ATTACHMENT A

Proposed Technical Specification Changes

Response To NRC Request For Additional Information

Figure 6.2-14

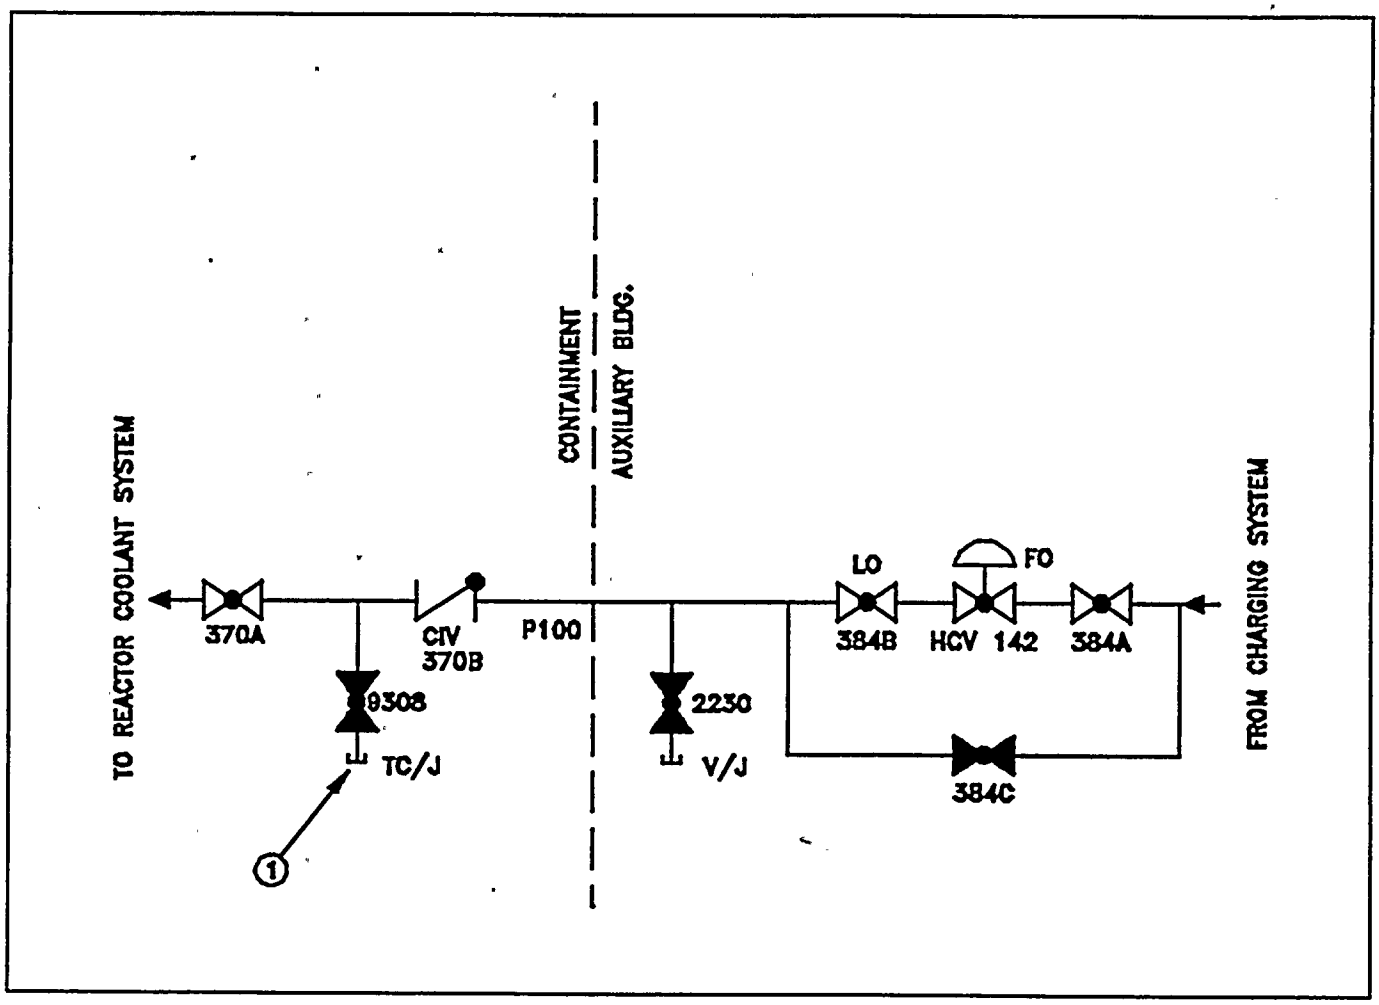
6. *Figure 6.2-14 includes a note that "CIV" is used to designate containment isolation valves on this and subsequent figures. This notation was also used on some other figures to designate an isolation boundary, but has been subsequently modified by deleting the letter "V." It is recommended that you identify "CI," or preferably "CIB," as notation for a containment isolation boundary or barrier by the use of a note on this figure. Also on Figure 6.2-14, Figure 6.2-16, and Figure 6.2-18, an arrow is shown for the check valves to designate flow direction. On other figures it appears that marked changes for check valves (Figures 6.2-37 and 6.2-38) were for the purpose to clarify flow direction (it is presumed that the intent is that the flow direction is from the upper side marking) yet no convention for such is provided. It would appear to be clearer to use the arrow symbol for consistency, since the presumed intent of marking does not work for a check valve shown in a vertical line such as in Figure 6.2-15.*

All UFSAR figures have been updated to identify containment isolation boundaries as "CIB" and valves as "CIV". All items identified with a CIB or CIV have also been added to the UFSAR table. The arrows on check valves have been deleted and new arrows have been placed on process lines to indicate direction of flow as necessary (i.e., incoming and outgoing).

| ROCHESTER GAS AND ELECTRIC CORPORATION<br>R. E. GINNA NUCLEAR POWER PLANT<br>UPDATED FINAL SAFETY ANALYSIS REPORT |
|---|
| Figure 6.2-24<br>Residual Heat Removal<br>to Loop B Cold Leg<br>Penetration 111 |

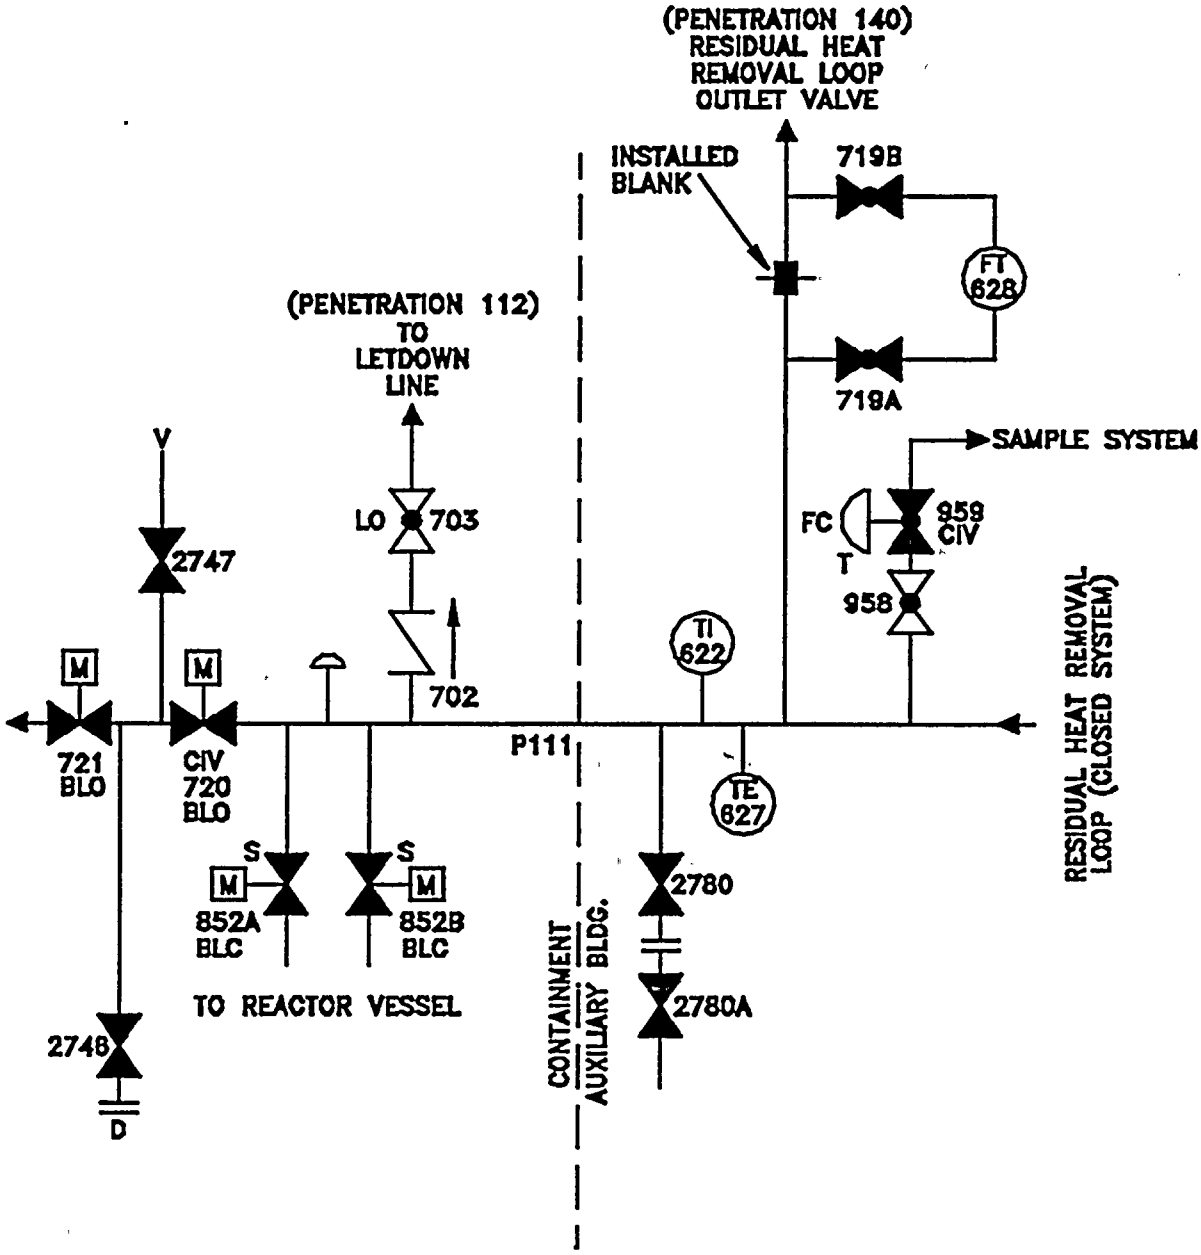
18. *On Figure 6.2-24, valve 959 should be noted as a CIV since it ensures that the Residual Heat Removal (RHR) system is a closed system on a CIS and should be listed in Table 6.2-13. Also, the valves to the safety injection system inside containment should be shown and listed in the table as CIVs as well as the check valve and the parallel valve shown connecting to the letdown line. If an exception is taken to this position, it should be justified.*

AOV 959 was already listed on Table 6.2-15 as a CIV; however, the "CIV" designator was missing for the valve on Figure 6.2-24. The figure has been revised accordingly. With respect to the "valves to the Safety Injection System", the wording on the UFSAR figure was incorrect. These two MOVs (852A and 852B) are used for low pressure injection to the reactor vessel. Consequently, both lines are completely inside containment and have no affect upon the integrity of RHR as a closed system (i.e., the failure of 720 to isolate would not create a release path from containment through the subject two lines). In addition, both MOVs open on a SI signal to provide a RHR injection path; consequently, they cannot be closed due to their function and were therefore not added as CIVs. This issue is addressed in a letter from the D. Crutchfield, NRC, to J. Maier, RG&E dated September 29, 1981.
